P6576
4921
2215

SERVICETEKNOTES

TABLE OF CONTENTS

**492/P CENTER FREQUENCY KNOB (A38 S2035)
REPLACEMENT PARTS**

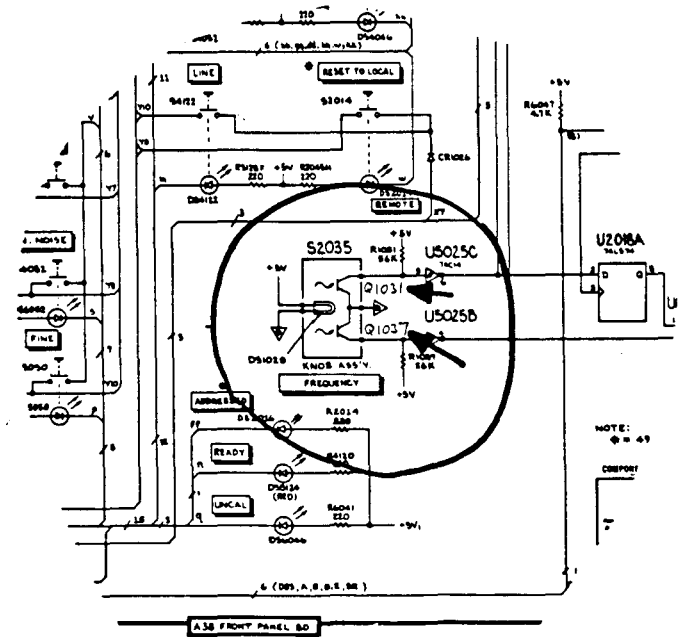
Due to the high replacement cost of (A38 S2035) the Center Frequency Knob for the 492/P, some of the internal parts were made replaceable. Refer to the figure below for the parts list and schematic locations.

492/492P		A38	} { DS 1029 150-0093-01 Q 1037 151-0629-00 Q 1031 151-0629-00
496/496P		A48

**492/P JUMPERS ON PRESELECTOR DRIVER
BOARD P/N 670-5552-03**

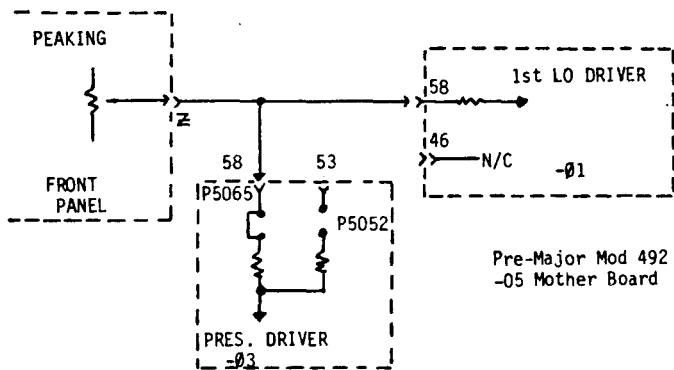
The new Preselector Driver has two plugs on it to match it to the particular first LO Driver and Mother Board with which it is being used.

1. In post major mod 492's (B03XXXX and above) and all 492/P's, P5052 should have a jumper on it and P5065 should be open. This connects the Peaking control to the Preselector Driver via the first LO Driver programmable peaking output on Pin 46.
2. In pre major mod 492's (below B03XXXX) with a first LO Driver, 670-5550-01 or -00, P5065 should have a jumper on it and P5052 should be open. This connects the Peaking control to the Preselector Driver via Pin 58 on the Mother Board connector. Pin 46 on the first LO Driver has no connection on the -01 board.

Presently in 492's with -06 Mother Boards, the Peaking control will work

with the jumper on either plug since there is an extra run in the -06 Mother Board between Pins 58 on the LO Driver, and Preselector Driver (see accompanying schematic). Connect the jumpers as in #1 above.

If the jumpers are incorrect on a 492/P, the Peaking control will be useable, but the Programmable Peaking will not work.

492/P VARIABLE RESOLUTION MODULE REPLACEMENT KIT (050-1467-00)

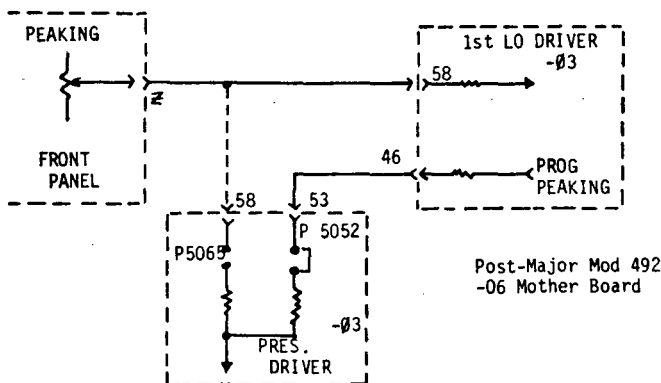
An 050-1467-00 replacement kit has been set-up to replace the Variable Resolution Module in the 492/P. The Variable Resolution Module, P/N 644-0163-00, was replaced by a New Variable Resolution Module, P/N 644-0163-04. The new, redesigned Variable Resolution Module requires a new calibration procedure which is included in the kit.

PARTS LOCATION GRID
SYNC GENERATOR ASSEMBLIES 670-4553-03
AND 670-4553-04 CHANGING TO 670-4553-05 AND 670-4553-06 RESPECTIVELY

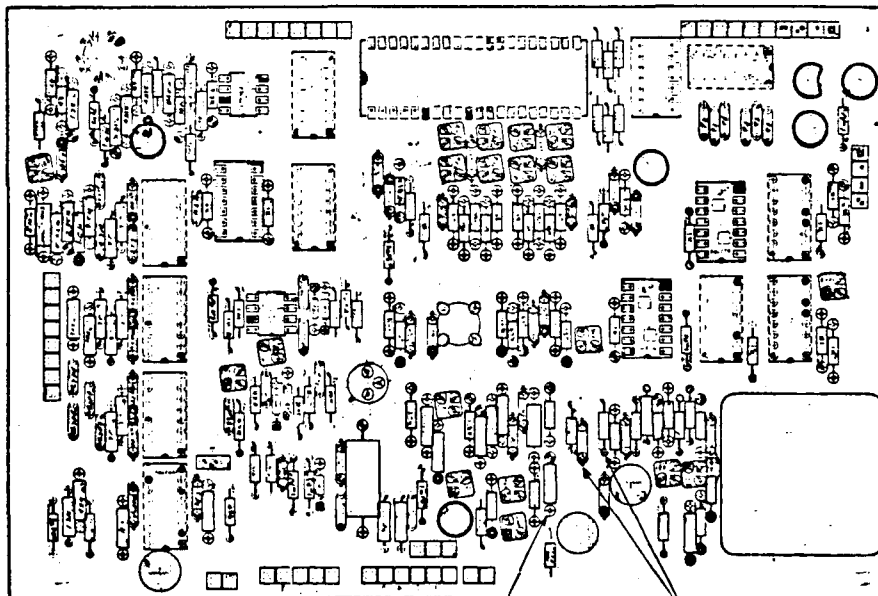
To allow the black burst adjustment (sub-carrier amplitude, R230) to be made more to the center of R230's rotation, R229 can be changed from the present 11.0K resistor to a 12.7K 1% resistor, 321-0299-00.

To assure that the subcarrier frequency remains constant when the front panel SUB-CARRIER switch is exercised in the internal mode with no Gen Lock signal applied to the rear panel, a 220pf capacitor (C237) can be added to the sync board as shown in the following diagrams.

CHANGE R229 FROM
321-0293-00 (11.0K, 1%)
TO 321-0299-00 (12.7K, 1%)

ADD C237 283-0108-00
(220pf, 10%) FROM
LEAD OF C229 TO LEAD
OF R237

EXPLODED VIEW OF OLD 154-0807-01 & 154-0808-01

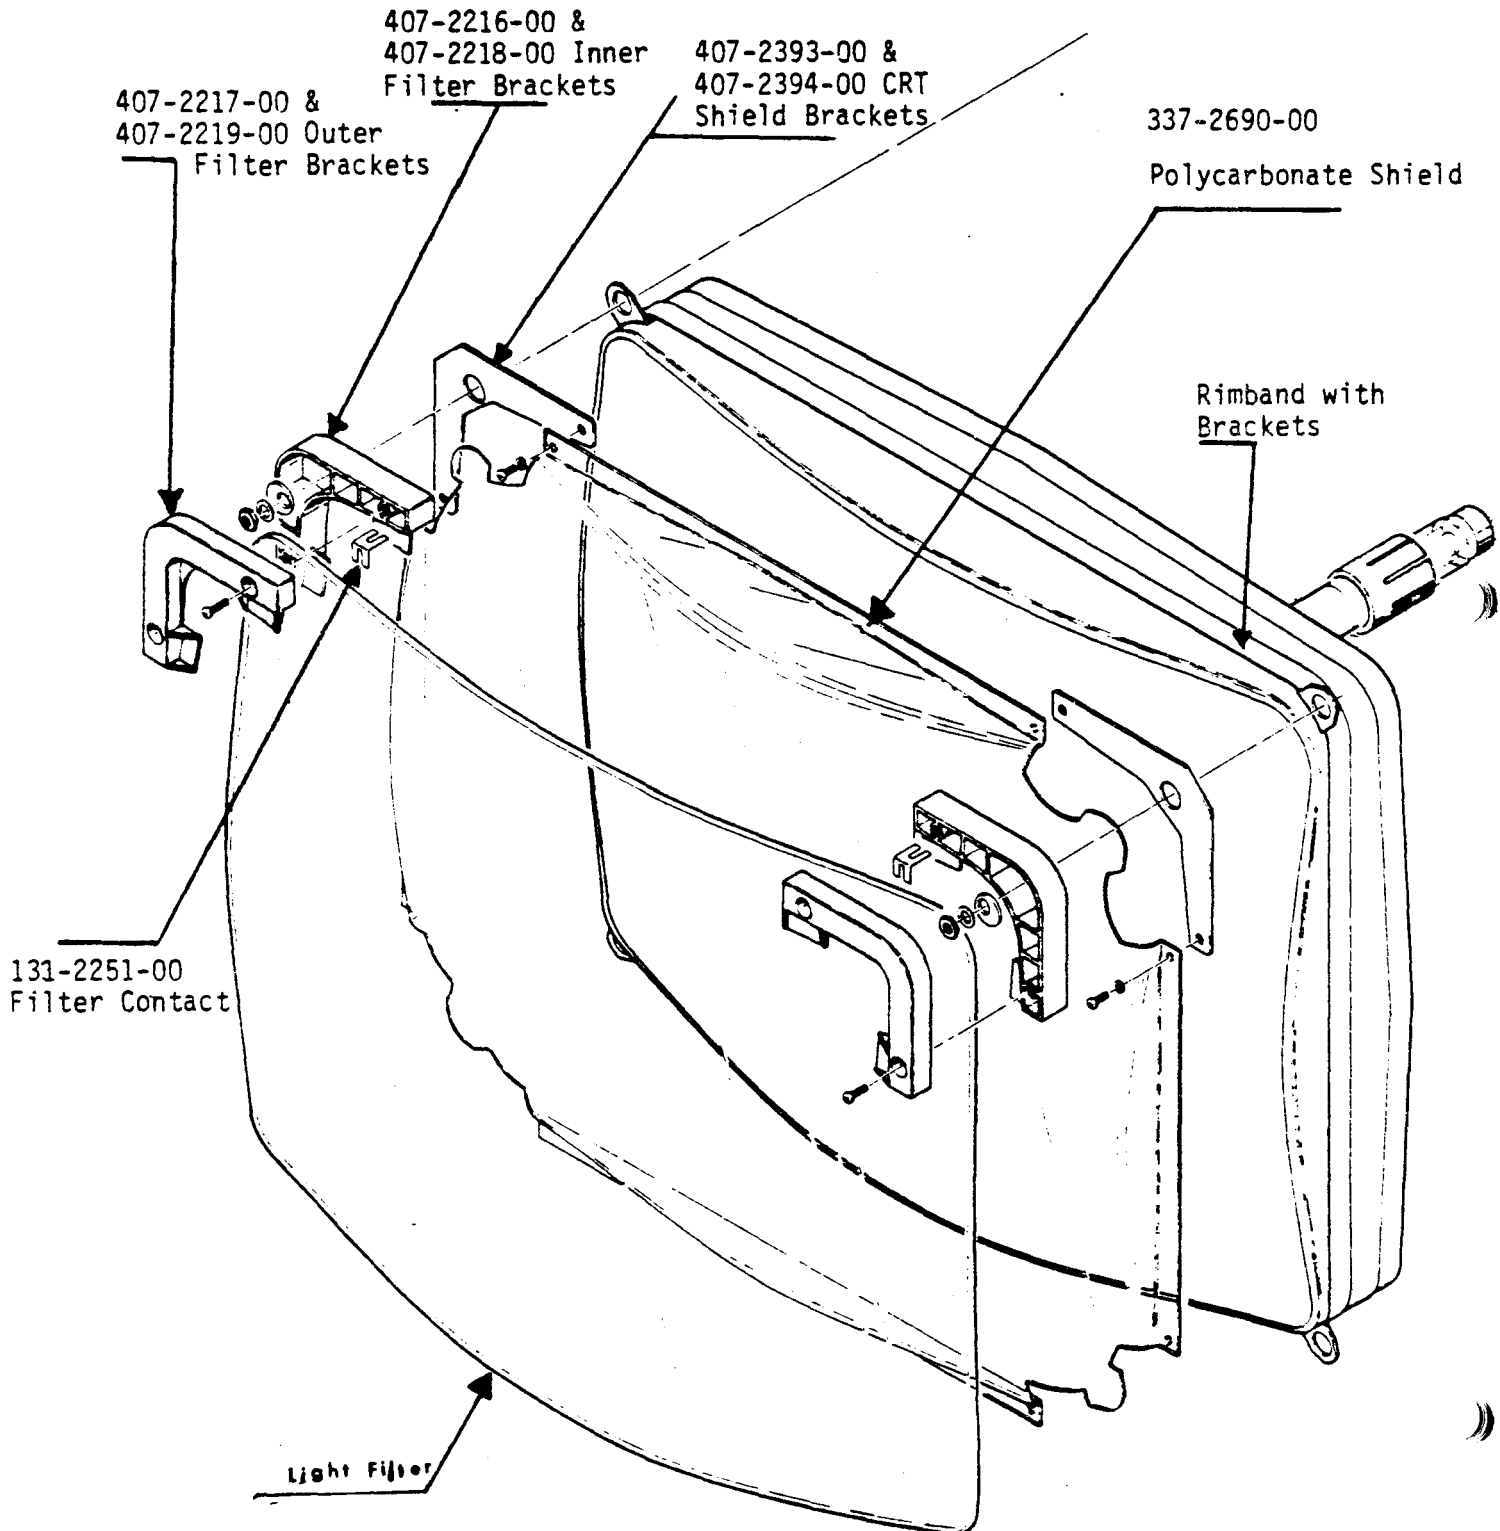
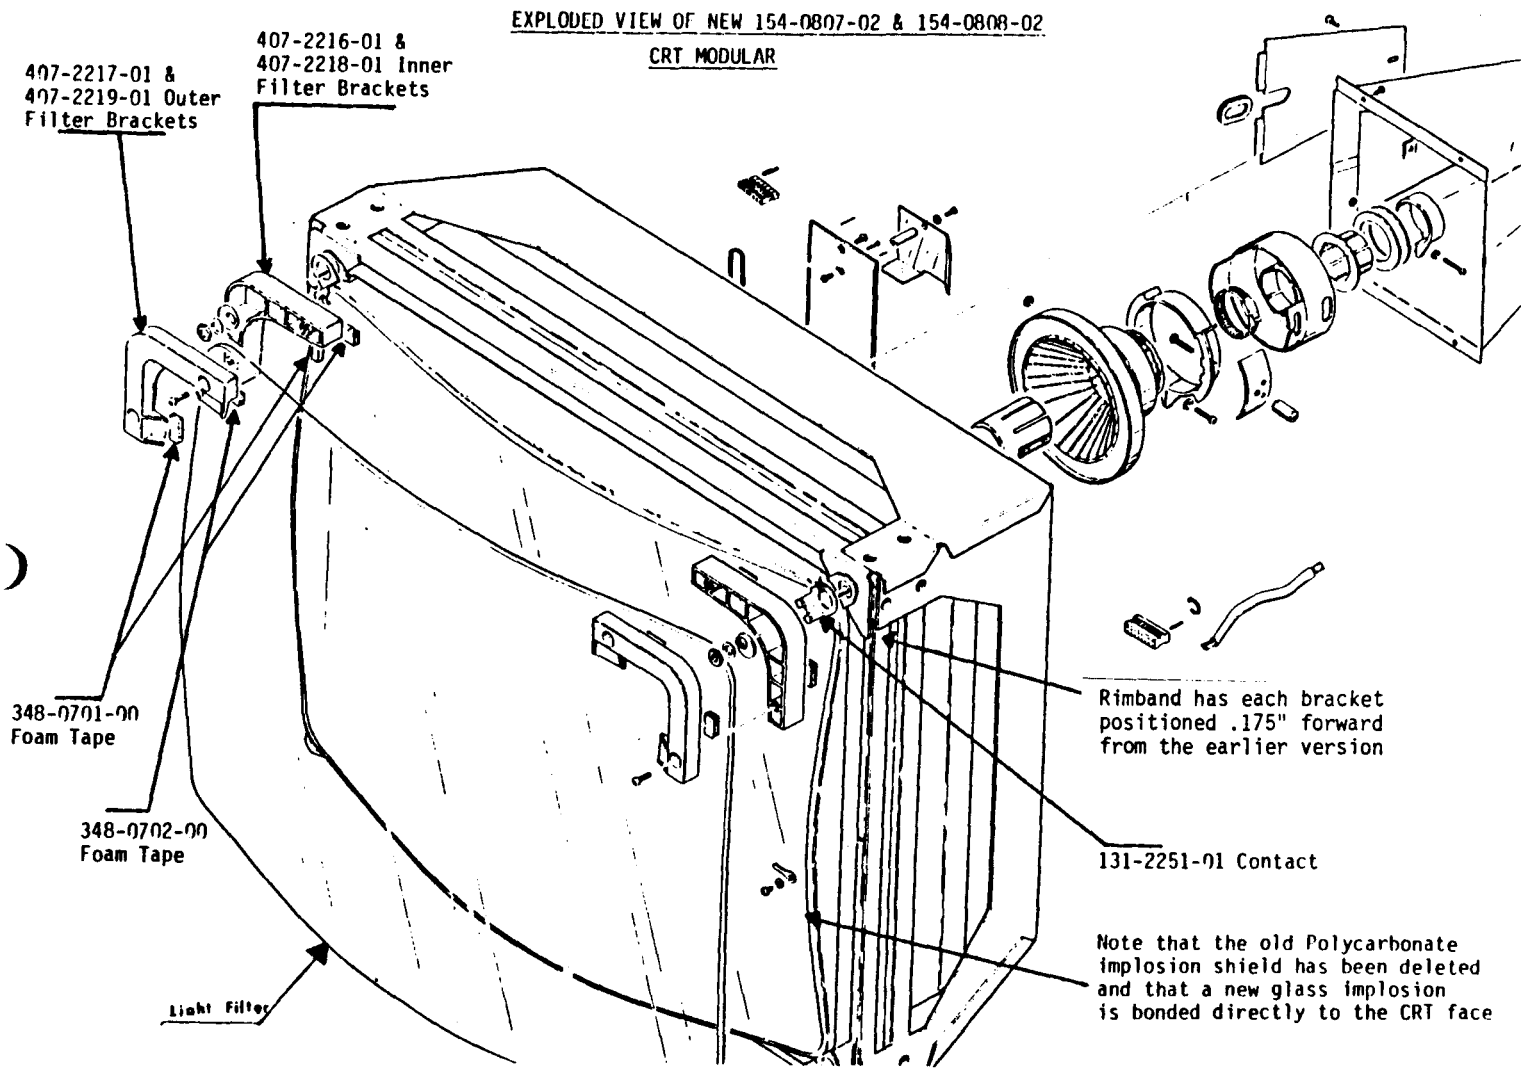
The manuals will be updated. In the meantime, please see the attached exploded views.

The attached exploded views show both

the old and the new versions. Note the part numbers and part names. Also note the placement of parts, especially the rubber cushions for the Light Filter. Notice that the brackets have a long and short edge. Be sure to orient them correctly when installing a new CRT module. The long edges should be in a horizontal direction.

Installation instructions:

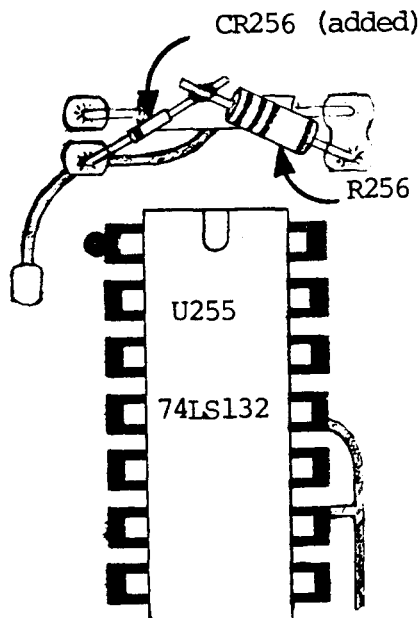
The 4054 will hang busy when connected to a 4611 that is powered down. The problem is fixed by a mod to the 4611 DVST Interface Board, P/N 670-5756-00. All 4611s with S/N B010765 and above have this mod installed.

- Disconnect power and remove the DVST Interface board from the unit.
- Locate U255 and R256 just above it.
- Lift the left end of R256.
- Solder in a diode (P/N 152-0141-02) cathode down, in series with R256. See illustration.

The part number suffix of the board rolls to 670-5756-01.
